California Air Resources Board

Public Hearing to Consider Proposed Amendments to the Small Off-Road Engine Regulations: Transition to Zero Emissions

Final Statement of Reasons for Rulemaking,
Including Summary of Comments and
Agency Response

Public Hearing Date: December 9, 2021
Agenda Item No.: 21-13-2

Figure 6

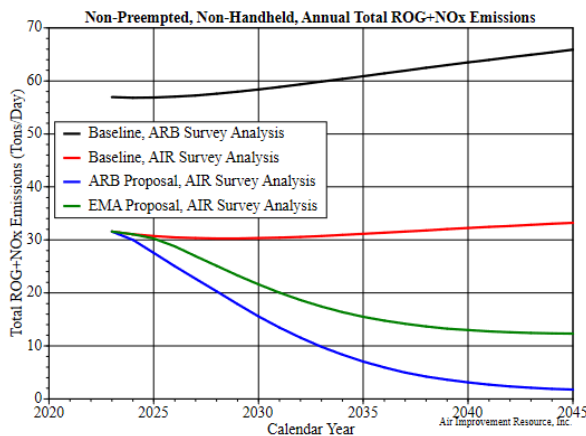
The ROG + NO_x emission inventories resulting from the EMA proposal in comparison to the CARB proposal are shown in Figure 6 below (reproduced from AIR's Report). This inventory analysis uses the updated AIR annual-use estimates. AIR found that EMA's proposal would reduce ROG + NO_x emissions from non-preempted, non-handheld equipment to about 11 tpd in 2045. (521-Docket)

Figure 7

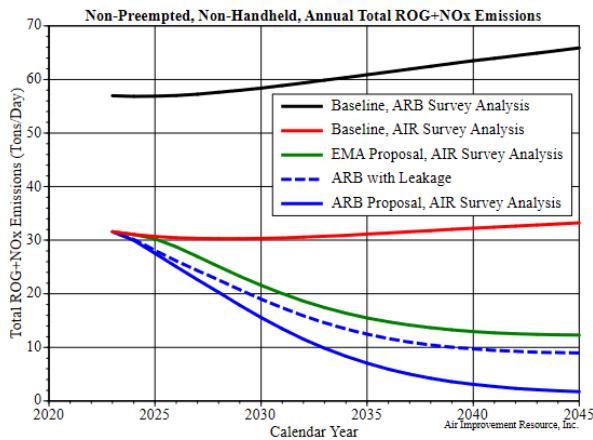
Figure 7 (also reproduced from AIR's Report) shows the comparative emission reductions if reasonably anticipated "leakage" impacts are taken into account. More specifically, Figure 7 factors in the impact of assuming that 50% of commercial landscapers' new SORE purchases and 10% of residential SORE purchases will be made out-of-state in response to CARB's ZEE mandates for SORE, starting in 2024. Significantly, Figure 7 does not include the impact from slower fleet turnover (reduced "scrappage"), which is another expected outcome from CARB's proposal, and which will further reduce the putative benefits of that proposal. As reflected in Figure 7, EMA's alternative proposal would largely match CARB's proposal with respect to anticipated ROG + NO_x reductions, but would do so at a fraction of the cost and without the large market dislocations and disruptions that CARB's Proposed Amendments will cause. (521-Docket)

Figure 6

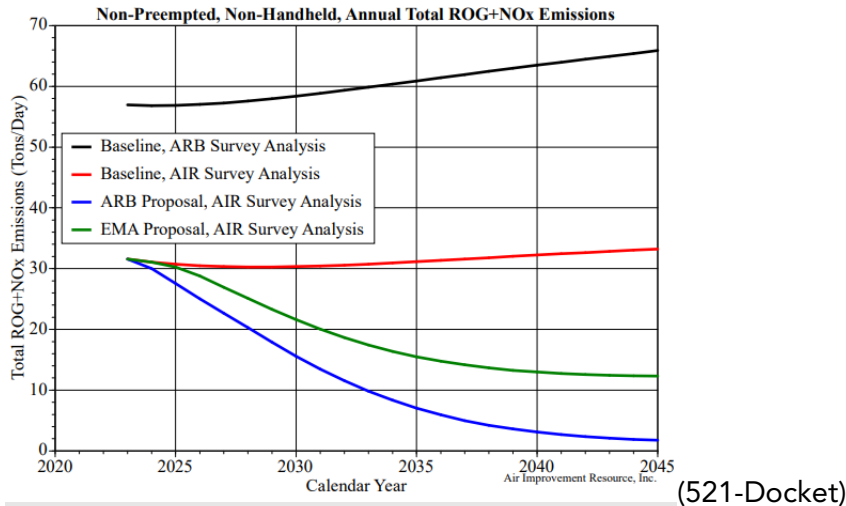
The ROG + NO_x emission inventories resulting from the EMA proposal in comparison to the CARB proposal are shown in Figure 6 below (reproduced from AIR's Report). This inventory analysis uses the updated AIR annual-use estimates. AIR found that EMA's proposal would reduce ROG + NO_x emissions from non- preempted, non-handheld equipment to about 11 tpd in 2045. (521-Docket)

Figure 7

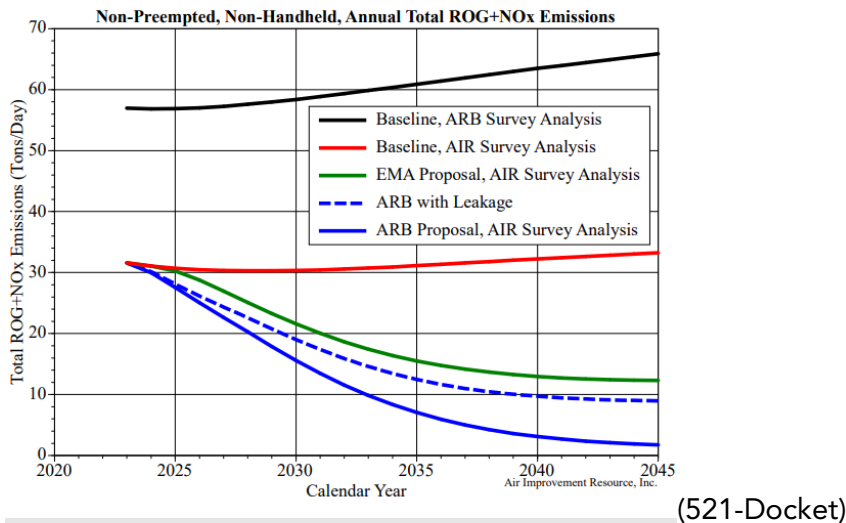
Figure 7 (also reproduced from AIR's Report) shows the comparative emission reductions if reasonably anticipated "leakage" impacts are taken into account. More specifically, Figure 7 factors-in the impact of assuming that 50% of commercial landscapers' new SORE purchases and 10% of residential SORE purchases will be made out-of-state in response to CARB's ZEE mandates for SORE, starting in 2024. Significantly, Figure 7 does not include the impact from slower fleet turnover (reduced "scrappage"), which is another expected outcome from CARB's proposal, and which will further reduce the putative benefits of that proposal. As reflected in Figure 7, EMA's alternative proposal would largely match CARB's proposal with respect to anticipated ROG + NO_x reductions, but would do so at a fraction of the cost and without the large market dislocations and disruptions that CARB's Proposed Amendments will cause. (521-Docket)

Figure 9

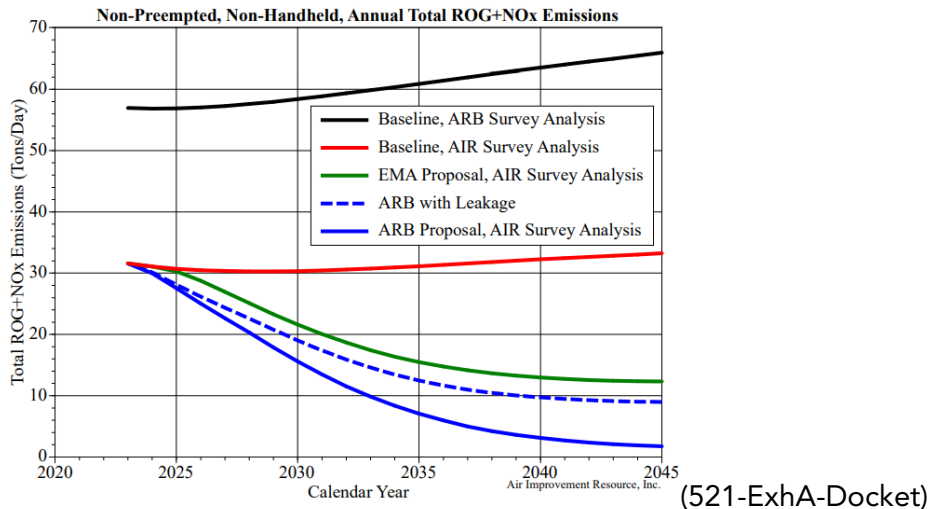
Figure 9 shows the impact of 50% landscape leakage and 10% residential/business leakage on the benefits of the ARB proposal. Purchases of equipment outside the state by landscaper, residential, and business users have a significant impact on the benefits of ARB’s proposal. In addition, while not specifically modeled, slower fleet turnover would also significantly reduce the benefits of the ARB proposal. (521-ExhA-Docket)

Figure 4

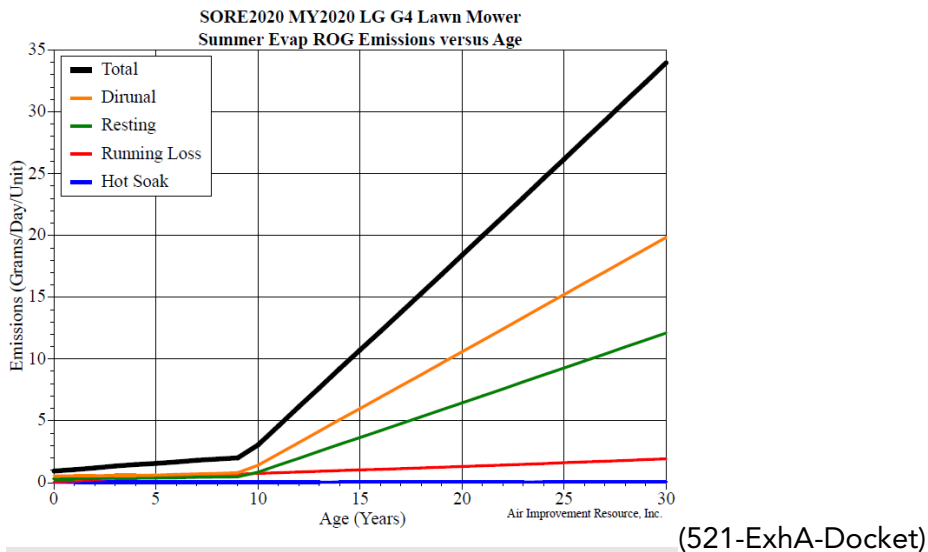
Figure 3 for generators shows a large increase in running loss emissions versus age, and the increase in running loss emissions drives total evaporative emissions higher. The other components are flat with age. Figure 4 for lawnmowers shows a large increase in diurnal and resting loss emissions for lawnmowers, which drives total emissions higher with age. (521-ExhA-Docket)

Figure 1: Total ROG+NO_x Annual Emission Rates versus Activity Non-Preempted, Non-Handheld*, Baseline Scenario

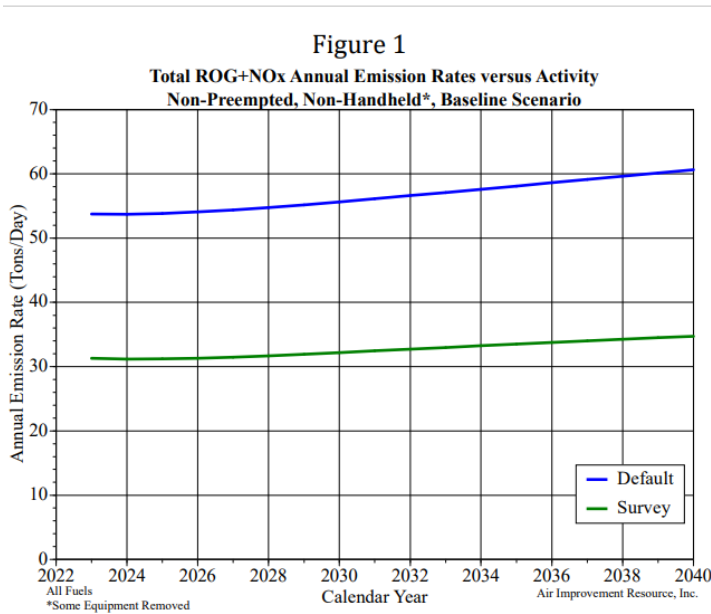
Figure 1 shows much lower small engine inventories for the more realistic activities calculated by AIR which was the main goal of the CSUF survey was to calculate a more accurate inventory of SORE emissions and modeling - than for the default ARB inventories. (521-ExhA-Docket)

Comment: Figure 6

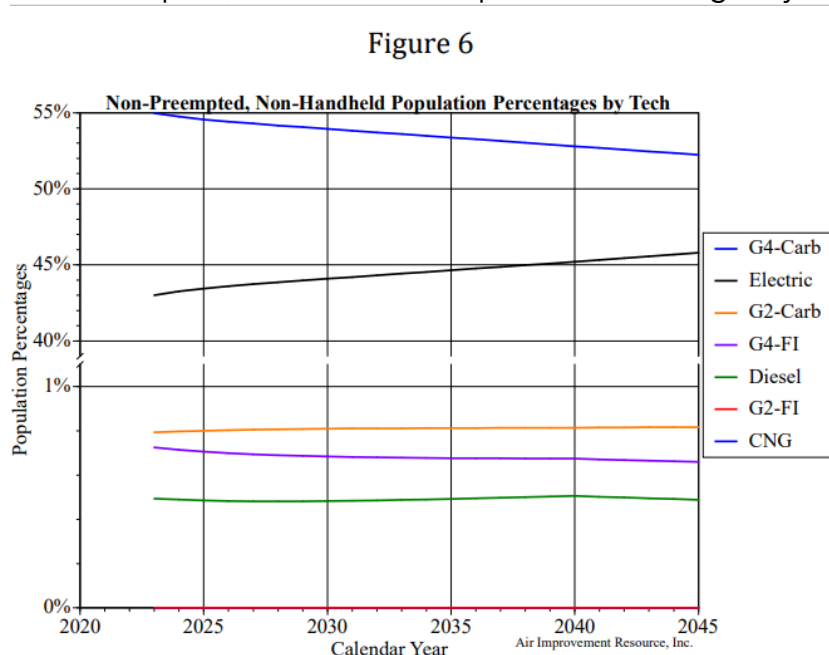
Figure 6 shows the penetration of electric equipment predicted by the SORE2020 model for non-handheld, non-preempted equipment for the 2023 to 2045 calendar years. The figure shows that the current electric percentage is about 43%, with growth over the next 22 years of only about 3%. This seems to be a very conservative projection for the baseline. The lower this projection is, the more benefit ARB can claim for its SORE regulation. There is little justification for this low of an electric fraction increase for the baseline in the SRIA or the ISOR based on the information provided in the Staff Report and SRIA, industry data provided by OPEI and publicly available data. (521-ExhA-Docket)

Figure 7

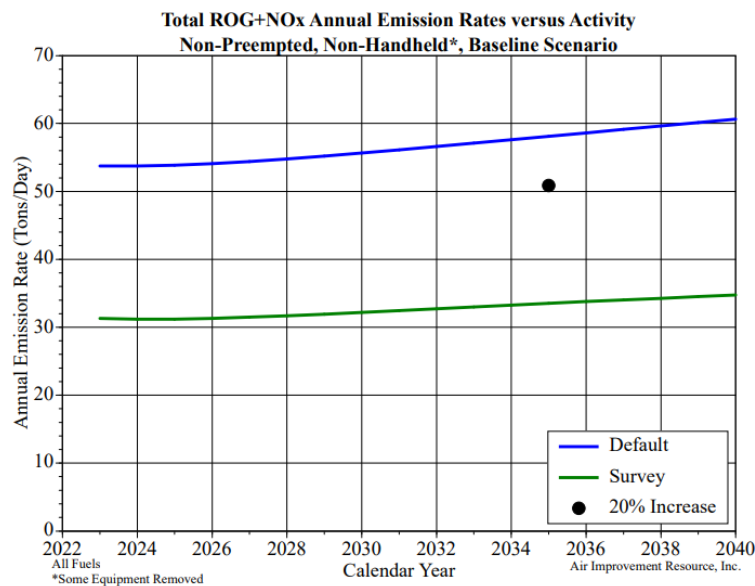
AIR evaluated a sensitivity case where we assumed that the electrification of non- handheld equipment would grow to be 20% higher than CARB staff estimates in 2035 in the baseline case. In this modeling, we used CARB's default activity estimates. Results are shown in Figure 7. The baseline inventory for 2035 drops from about 58 tpd to 51 tpd. (521-ExhA-Docket)

Figure 5-5 – EPA Annual PLT Estimated U.S. Directed Engine Production (524-Docket)

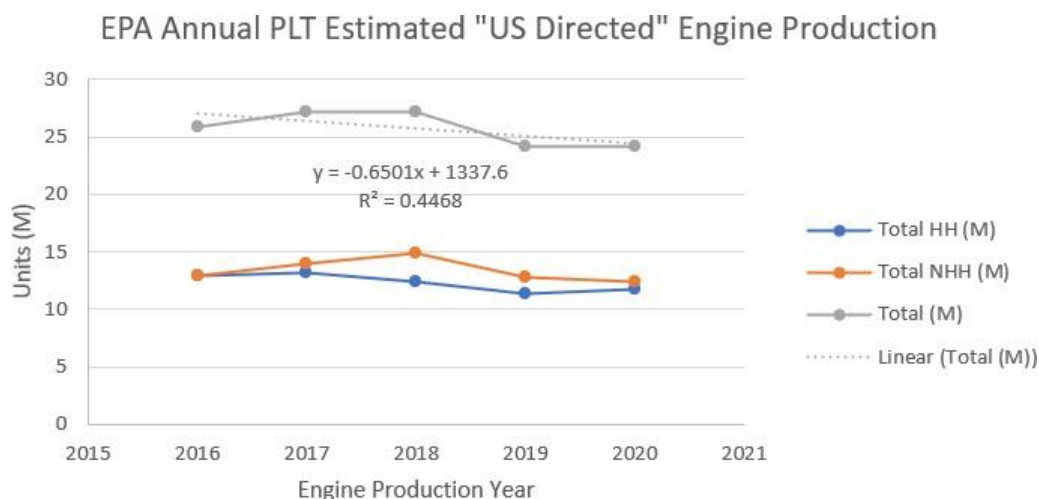
Comment: The assumptions included in the Proposed Rule and SORE2020 are also contrary to manufacturer 50-state EPA Production Line Testing reports. At OPEI's request, EPA provides OPEI annual PLT estimated U.S. directed engine production summaries. Total and handheld engine sales exhibit negative trends from 2016 to 2020. See Figure 5.5. (524-Docket)

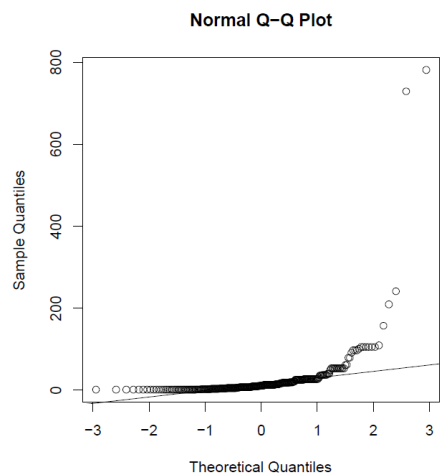
Since the Box Cox Transformation requires positive data, all activity values were increased by 1. The Q-Q below shows that the data are still highly skewed. (A normal distribution will have the symbols lie along the line.) (5005-Docket) (5006-Docket)

Box Cox Transformed Lawn Mower Annual Activity

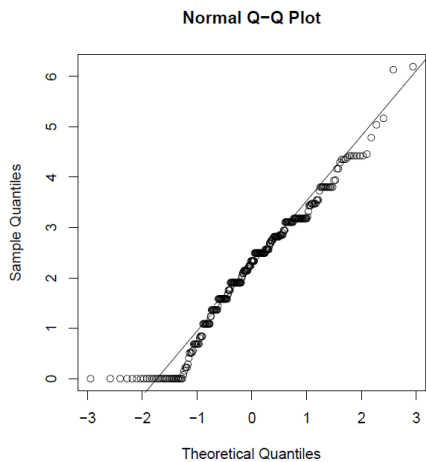
The next step was to perform the Box Cox Transformation on the data. This resulted in a more normally distributed Q-Q plot, but the 32 zero activity entries are an issue. (5005-Docket) (5006-Docket)

Box Cox Transformed Lawn Mower Annual Activity

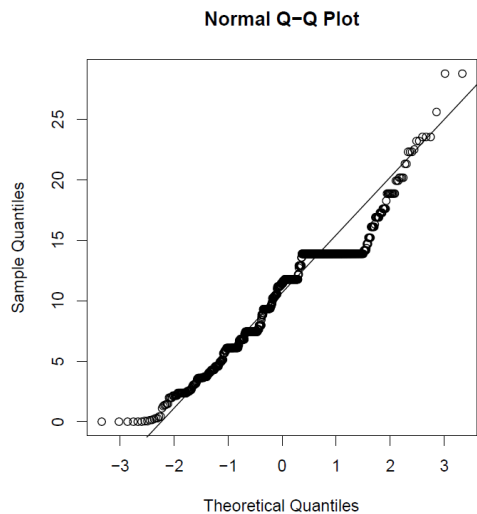
The next step was to perform the Box Cox Transformation on the data. This resulted in a more normally distributed Q-Q plot.

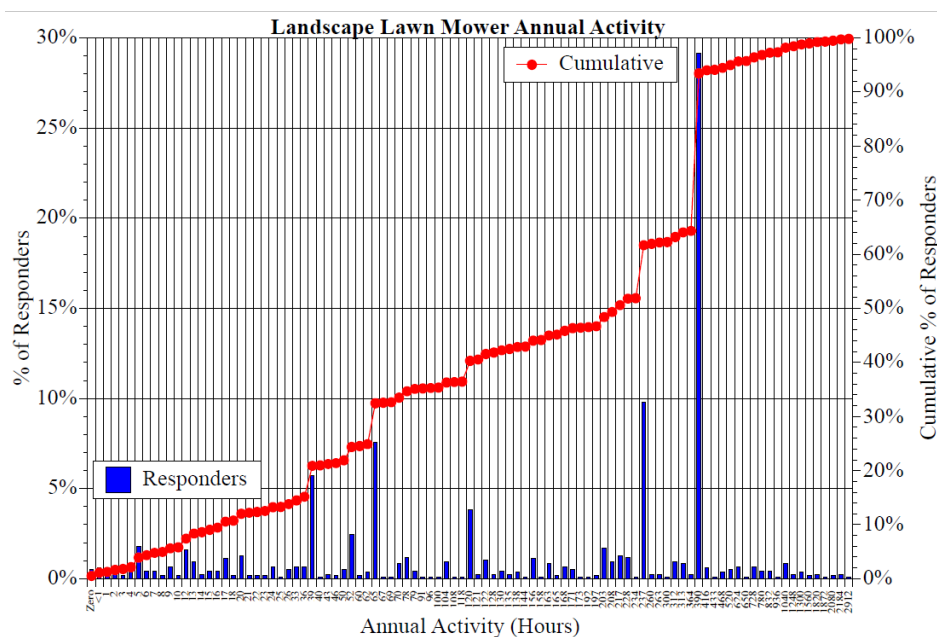
However, an abnormality is present in the Q-Q plot. The horizontally flat area indicates that something is very odd about the data. As a result, the following plot was created.
